NEW ELEMENTARY SCHOOL
 9801 HIGHLAND KNOLLS DR
 BAKERSFIELD CALIFORNIA 93306

NEW MIDDLE SCHOOL
 4115 VINLAND ROAD
 BAKERSFIELD CALIFORNIA 93306

SHEET IDENTIFICATION NUMBER
E-122A
 SHEET OF

REQUEST:
 RDM Electric - 7/12/12
 Reference Sheets K-2, K-5, K-6 & E-122A
RFI 91

KITCHEN ELECTRICAL PLAN BUILDING A

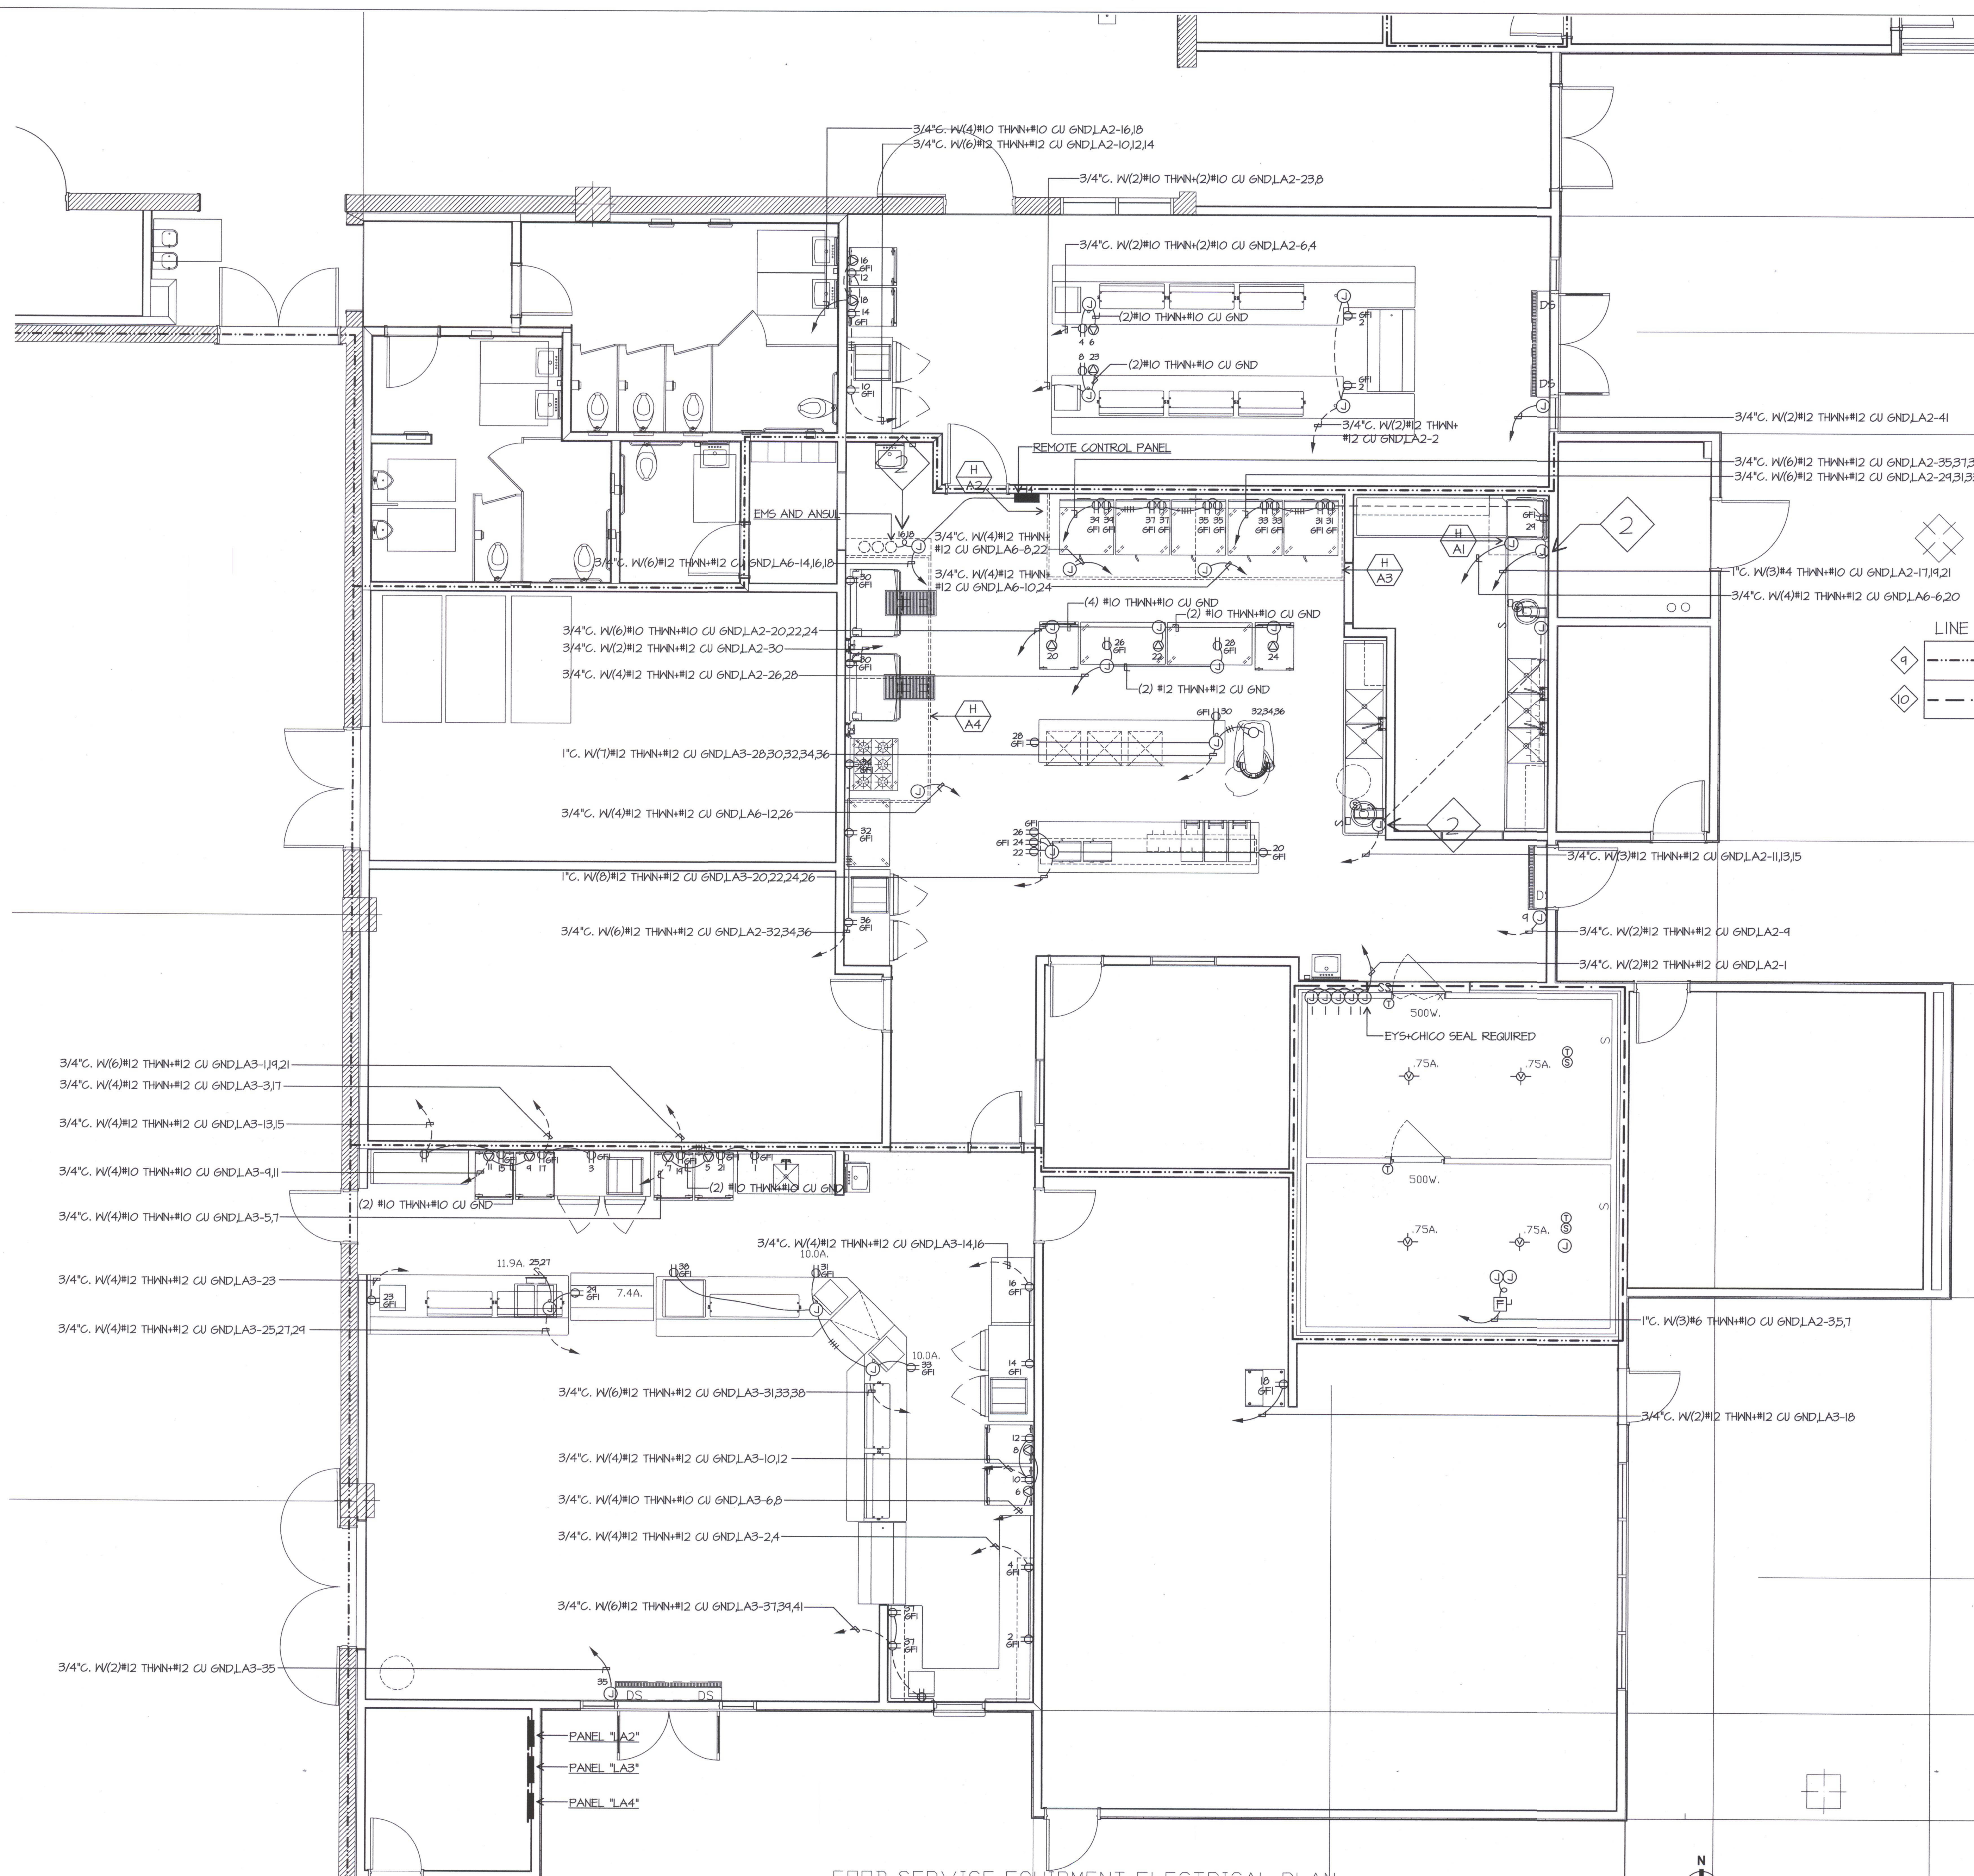
Both the Kitchen and Electrical Plans show receptacles to be installed at kitchen counters #17, 22, 36, 37, 43, 44 and 45. These are freestanding kitchen counters with no back or front panels. Please provide a detail that shows how to mount these receptacles.

REQUEST:
 RDM Electric - 3/19/13
 Reference Sheet E-122A
RFI 284

The electrical plan for Building A shows a remote control panel to be installed on the north wall of Room A-123. Room A-123 is to be used for fire suppression. Please provide the following information for this panel: what panel requirements are needed, who is to provide it, what does it control and in it to be surface mounted or recessed?

ANSWER:
 See the attached sketch for a suggestion. The electrical is provided by the job of electrical. Please refer to the Electrical Engineer.
 CND by BE: 2/13/2012

ANSWER:
 See sheet E-124 - 3/25/13
 Remote panel is part of the fire suppression system. Install as directed by electrical sheets and coordinate with fire suppression system installer.
